**CASE #20-ZONEPA-0116 - STATEMENT OF COMPLIANCE WITH PLAN 2040
COMPREHENSIVE PLAN FOR LOUISVILLE METRO**

Location: 4805, 4809, 4811, 4813, 4901, and 4907 Bardstown Road
Proposed Use: Multi-Family Residential
Request: Zone Change from R-4 and C-1 to R-7

22-ZONE-0012

Figure 2.1 - Narrow Laurel Springs Dr bridge marked by hazard signs.

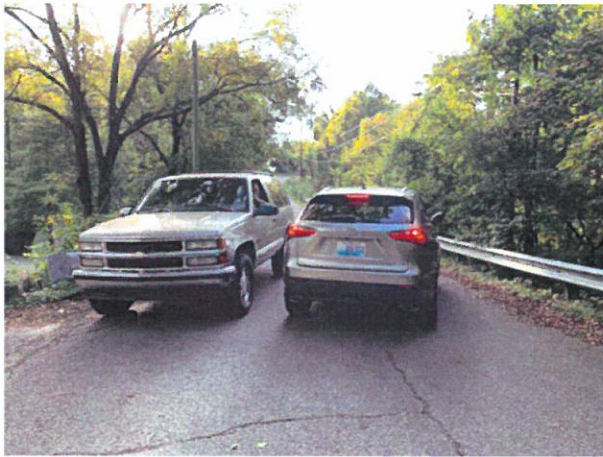
- Laurel Springs Dr is a narrow roadway with no sidewalks, no street lights, no bike lanes, and no public transportation access. See figure 2.1.
- Laurel Springs Dr is not taken care of by the city: no snow removal, no grass cutting

- The car and pedestrian entrance from Laurel Springs Dr be removed

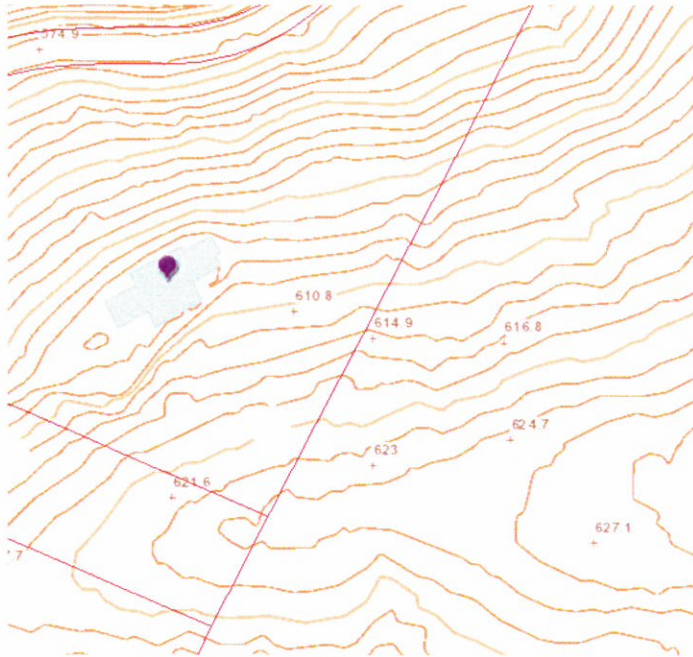
- According to section renderings, these massive 55-foot buildings are on land that is already 10 to 15-feet higher than adjacent properties. There may also be an additional 8-feet of backfill required (per geotechnical study and neighborhood meeting). Thus, these buildings will appear 78 feet to us who live below. See figure 3.1.

Figure 3.2 - Potential areas of concern for Carbon Monoxide, Plan 2040 Core Graphics (<https://louisvilleky.gov/planning-design/document/updatedcoregraphics2018pdf#page=18>)

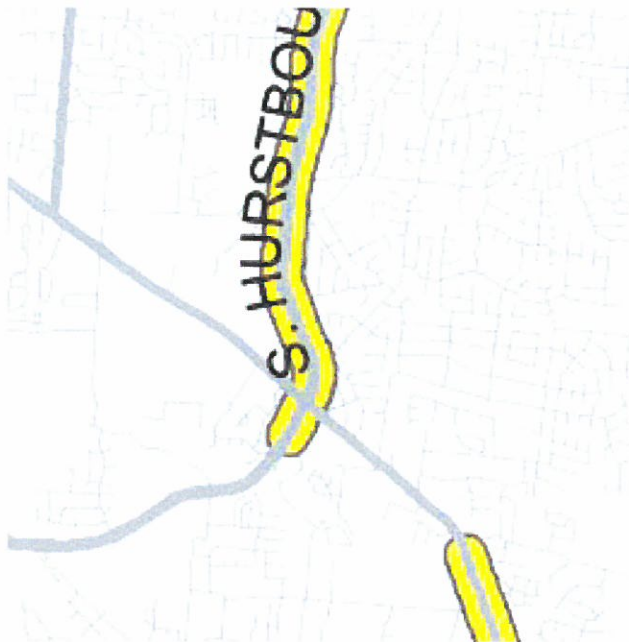
- A larger buffer zone with more trees will also help start the restoration of the mature trees that will be destroyed by the developer.
- According to Plan 2040, this area is at high risk for carbon monoxide. By adding more tree coverage along the perimeter, we can help improve the air quality and reduce health problems from carbon monoxide exposure. See figure 3.2.

Figure 5.1 - 4700 S Hurstbourne Pkwy underground stream exiting at cliff 4819 Walnut Hills Dr (left), approximate location of sinkholes according to developer's plans, and the approximate location of sinkholes on abutting properties (right).

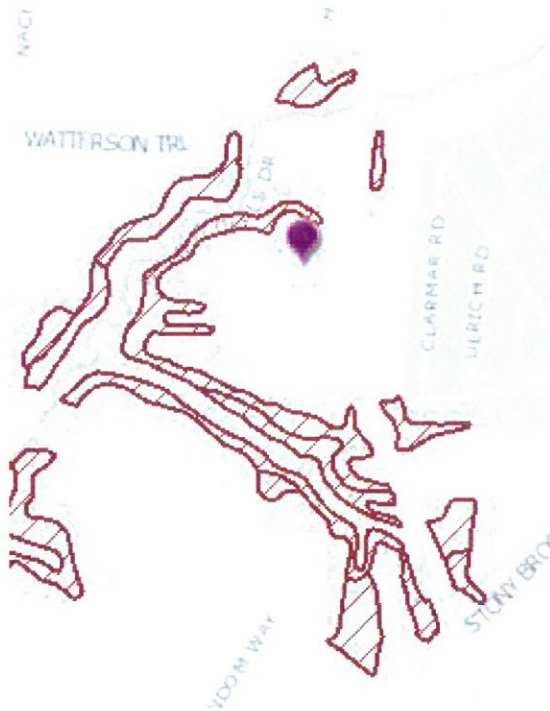
- There are sinkholes on abutting properties that are very close to the property line that the engineers failed to identify. In fact, we have reason to believe that one of these may be an underground cave or stream that flows from the 4700 S Hurstbourne Pkwy property, beneath a residents house, and ends up in the protected creek below. See figure 5.1

- For an unaffiliated third-party to conduct a geotechnical / impact study on the adjacent Walnut Hills and Laurel Springs properties.

Figure 2.2 - Two vehicles cannot safely pass each other on Laurel Springs Dr without maneuvering slowly to the side or backing up to make room.

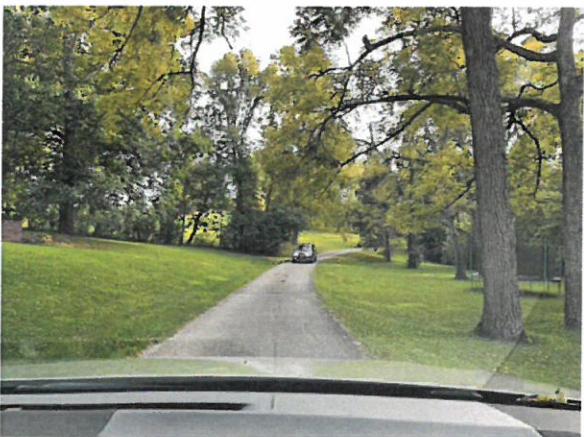
- Two cars cannot safely pass each other on Laurel Springs Dr. See figure 2.2.
- Walnut Hills Dr is a one-lane road with no sidewalks, no street lights, and no bike lanes. See figure 2.3.

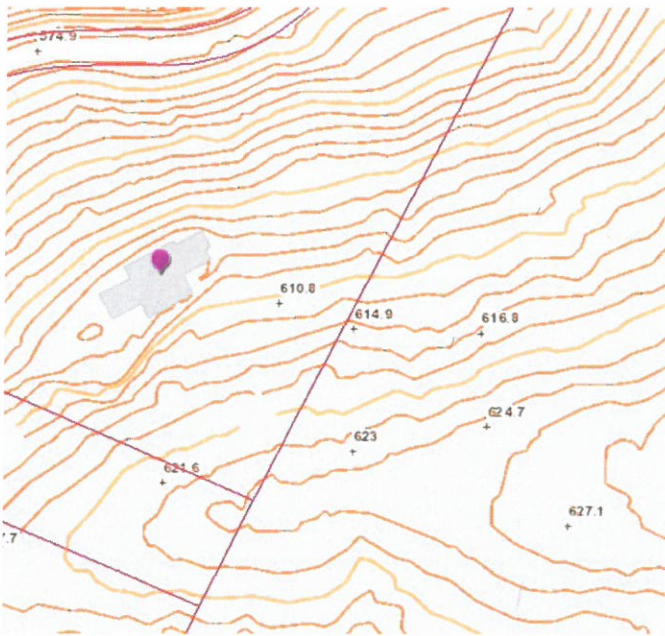
- According to section renderings, these massive 55-foot buildings are on land that is already 10 to 15-feet higher than adjacent properties. There may also be an additional 8-feet of backfill required (per geotechnical study and neighborhood meeting). Thus, these buildings will appear 78 feet to us who live below. See figure 3.1.

Figure 3.2 - Potential areas of concern for Carbon Monoxide, Plan 2040 Core Graphics (<https://louisvilleky.gov/planning-design/document/updatedcoregraphics2018pdf#page=18>)

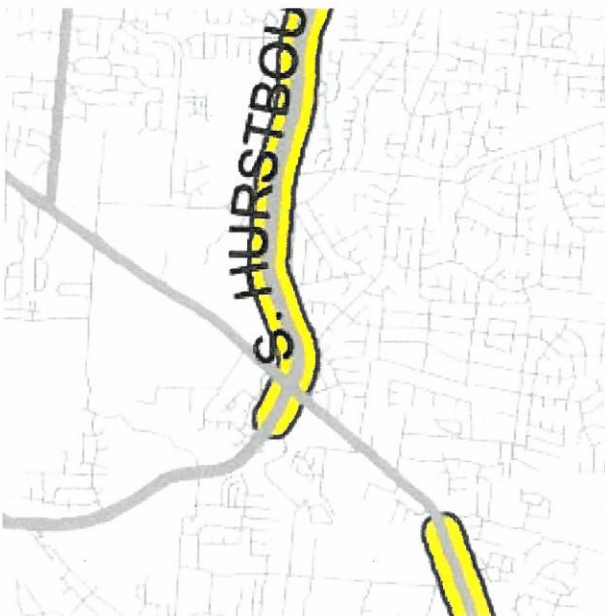
- A larger buffer zone with more trees will also help start the restoration of the mature trees that will be destroyed by the developer.
- According to Plan 2040, this area is at high risk for carbon monoxide. By adding more tree coverage along the perimeter, we can help improve the air quality and reduce health problems from carbon monoxide exposure. See figure 3.2.

Figure 5.1 - 4700 S Hurstbourne Pkwy underground stream exiting at cliff 4819 Walnut Hills Dr (left), approximate location of sinkholes according to developer's plans, and the approximate location of sinkholes on abutting properties (right).

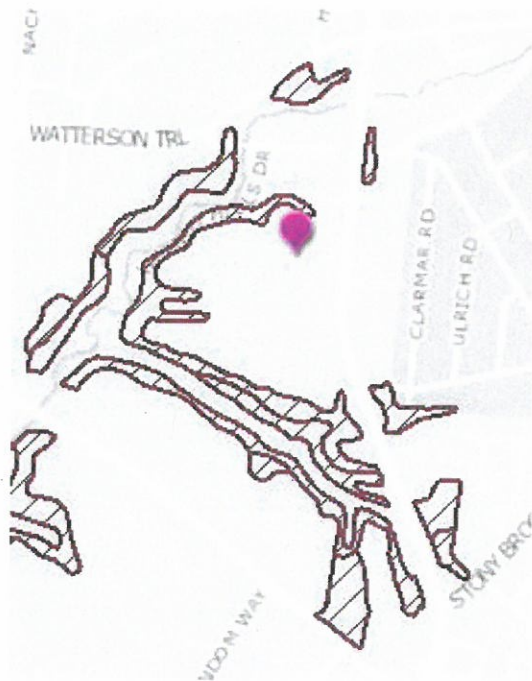
- There are sinkholes on abutting properties that are very close to the property line that the engineers failed to identify. In fact, we have reason to believe that one of these may be an underground cave or stream that flows from the 4700 S Hurstbourne Pkwy property, beneath a residents house, and ends up in the protected creek below. See figure 5.1

- For an unaffiliated third-party to conduct a geotechnical / impact study on the adjacent Walnut Hills and Laurel Springs properties.

KENNETH & KAREN HABENSTEIN
4805 WALNUT HILLS DR
T.B. 44 LOT 502
D.B. 5803 PG. 367
NFD/R4

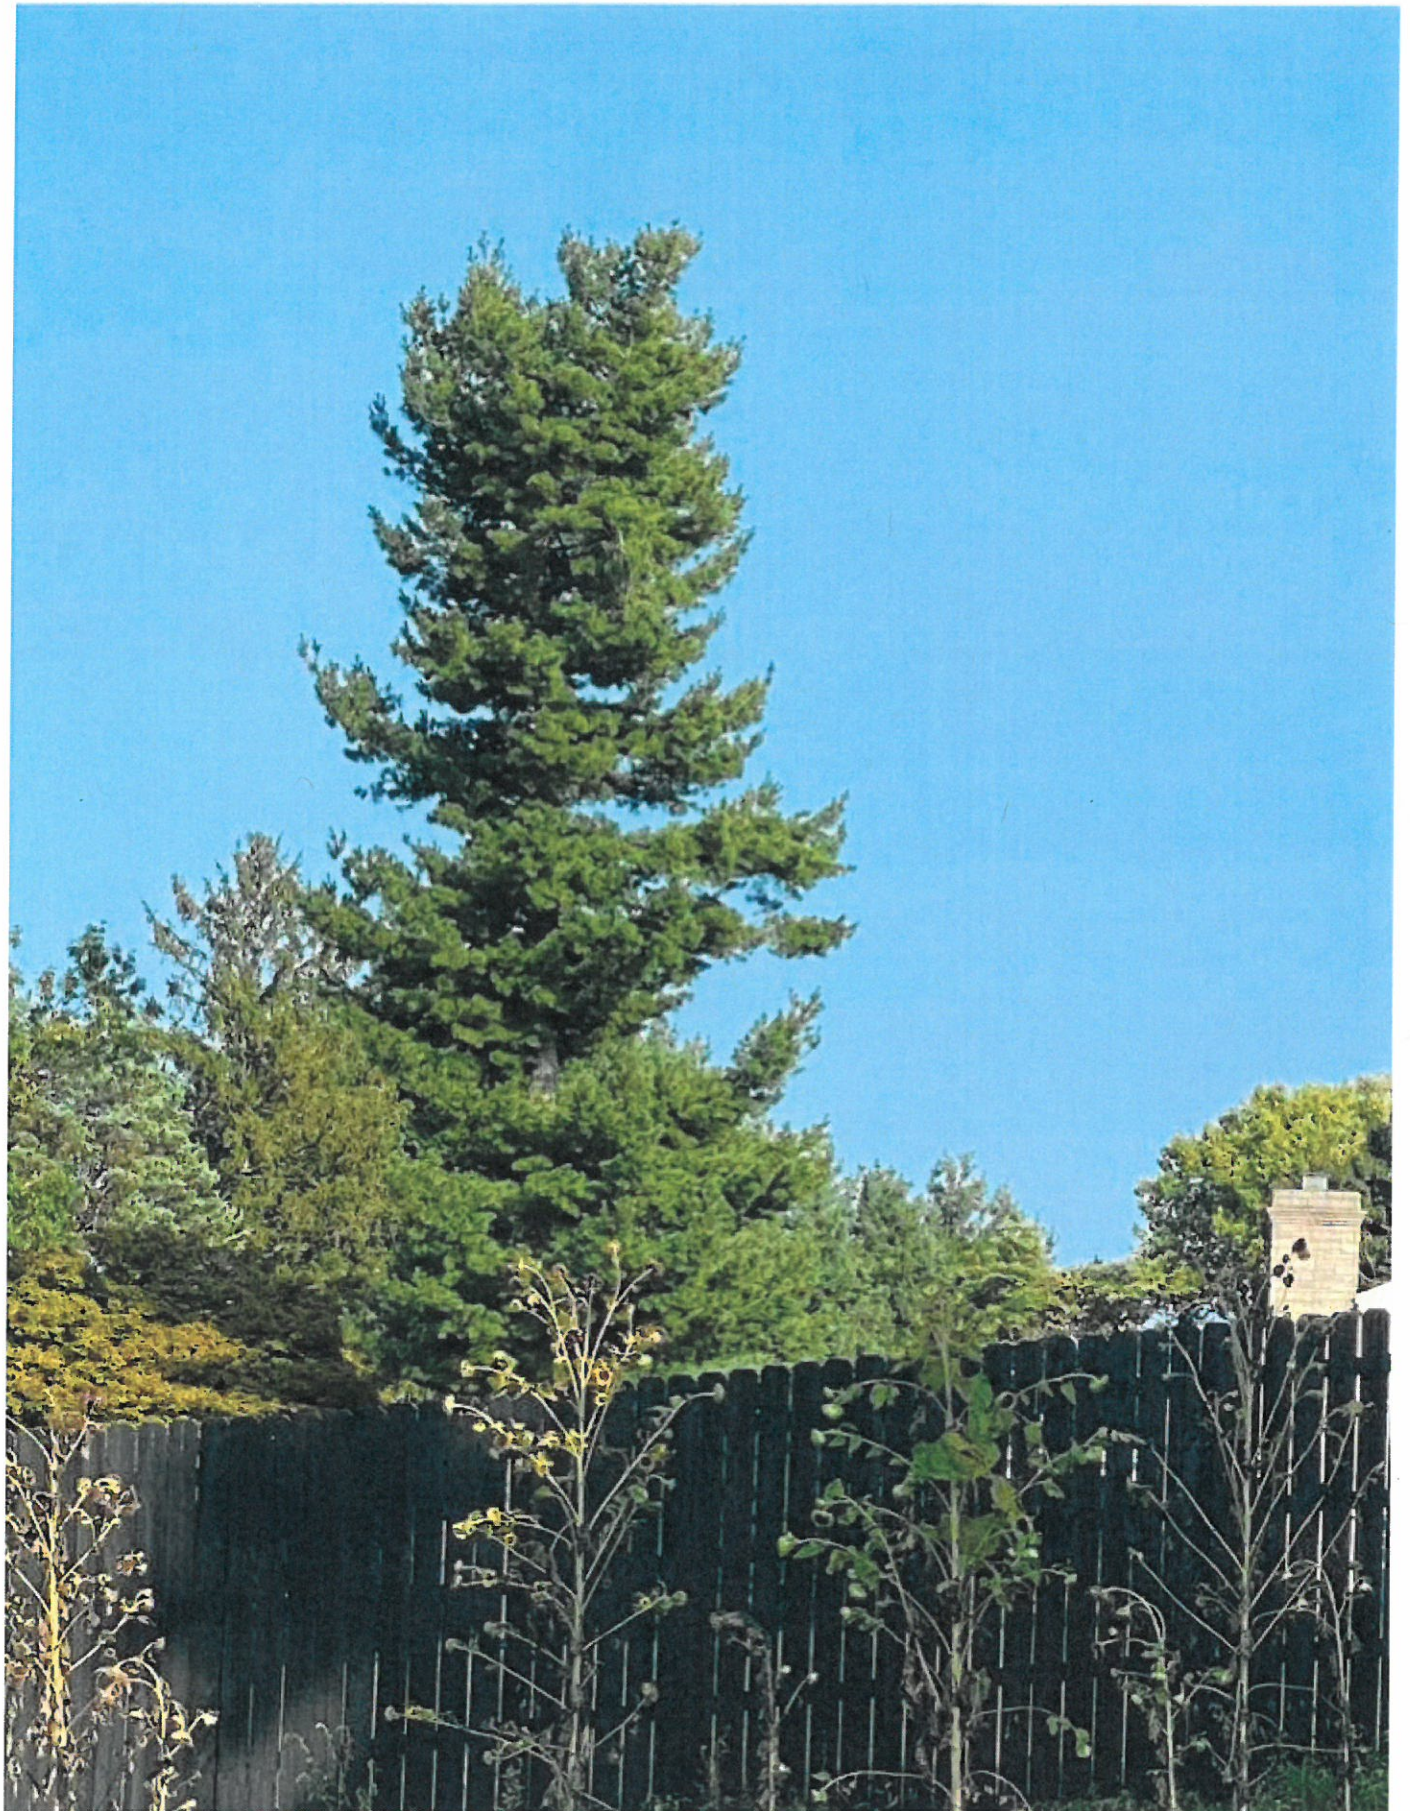
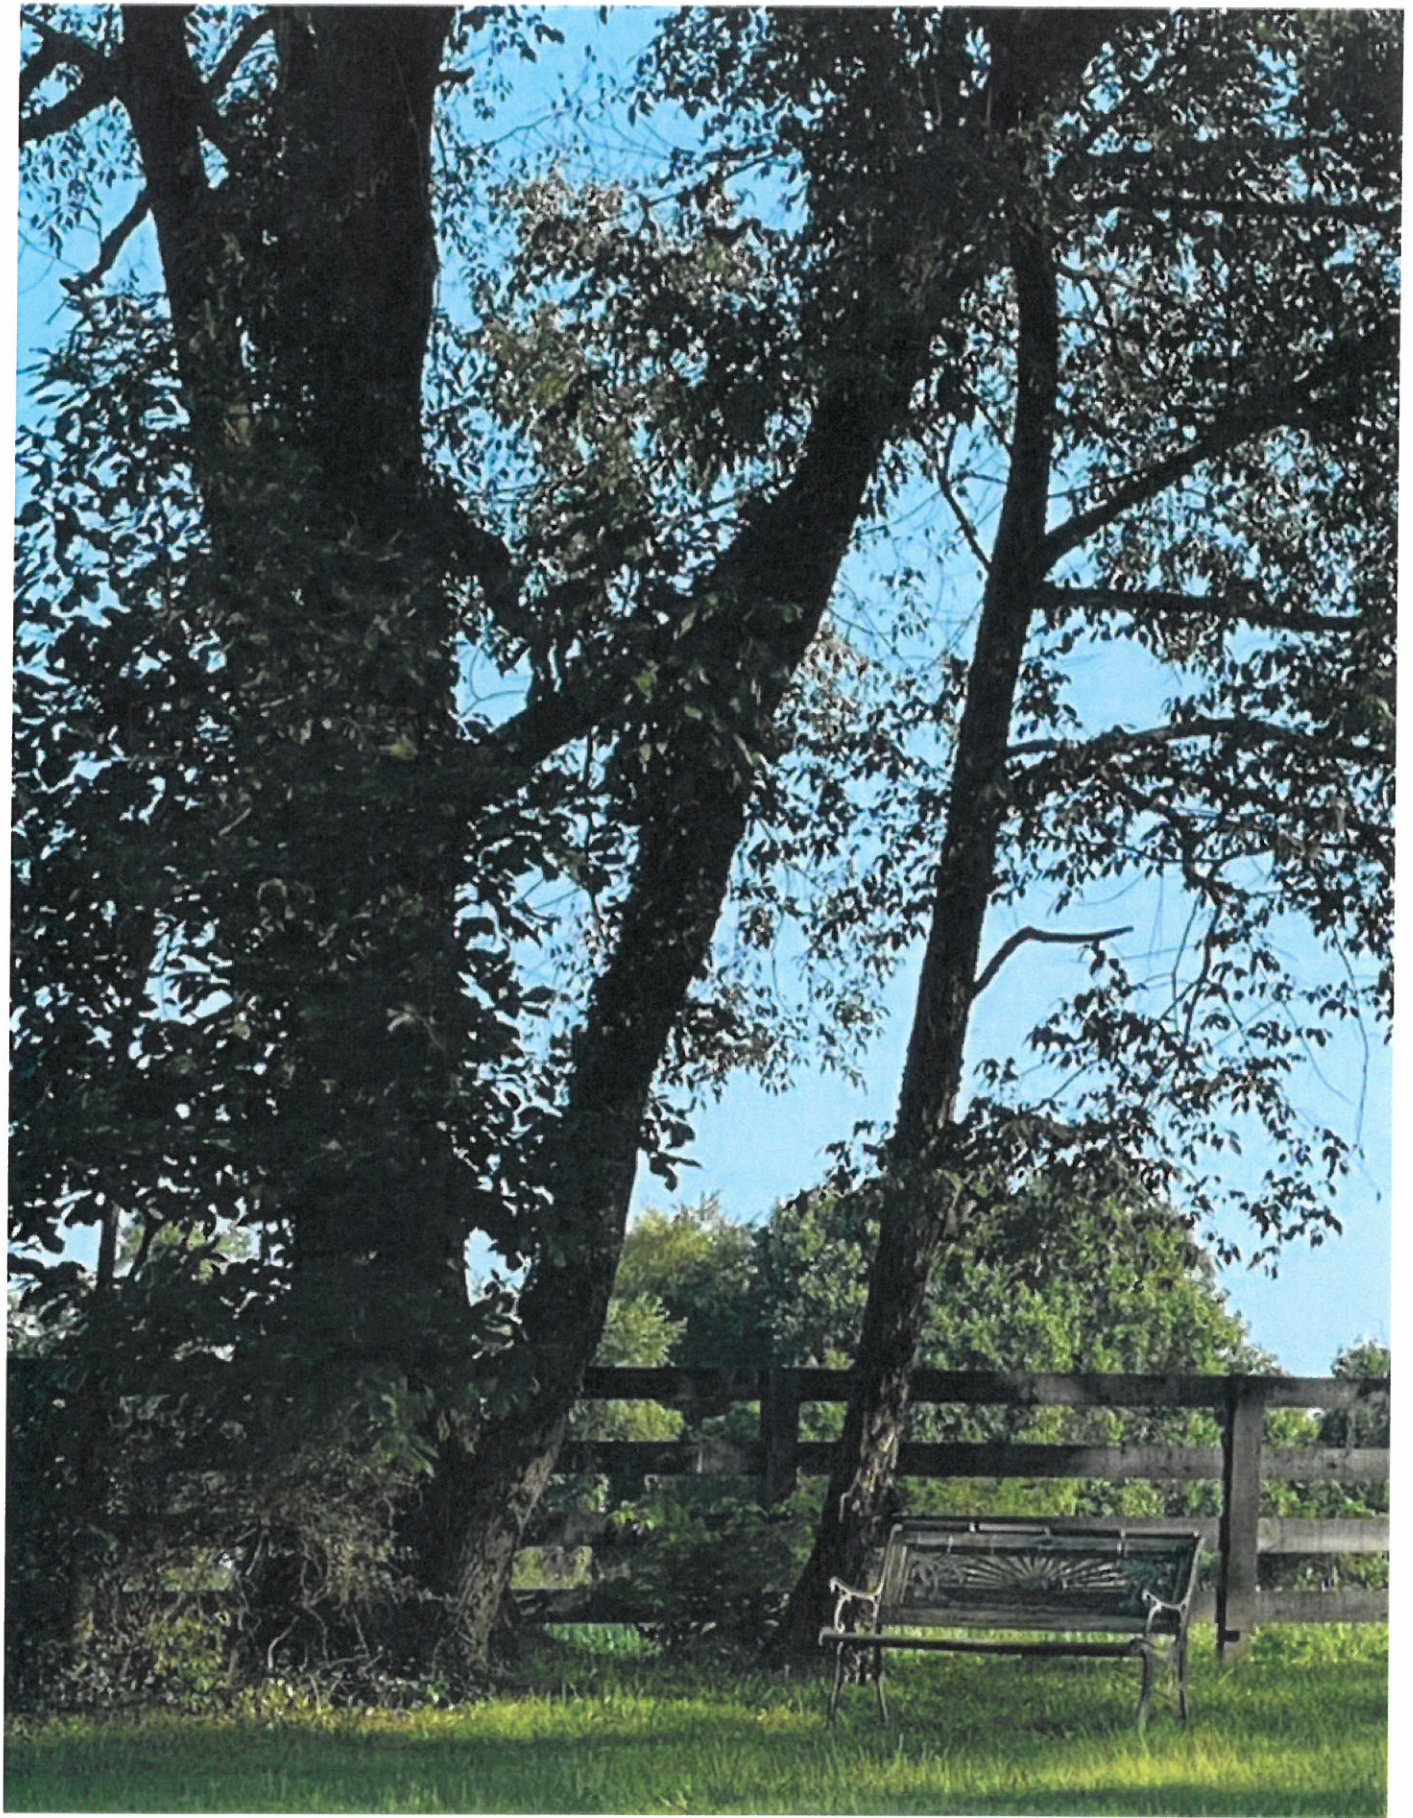
First and foremost, the developer has proposed 3-story and 4-story buildings towering over my home, with only a 6-foot fence to set us apart. These buildings are literally right on top of my home and the balconies will be looking directly into all my bedrooms, living room, and kitchen, in addition to my outdoor patio area, which is very important to us.

Because my home is downhill from these buildings, they will appear even larger from my view as my home is sloped downhill from this development.
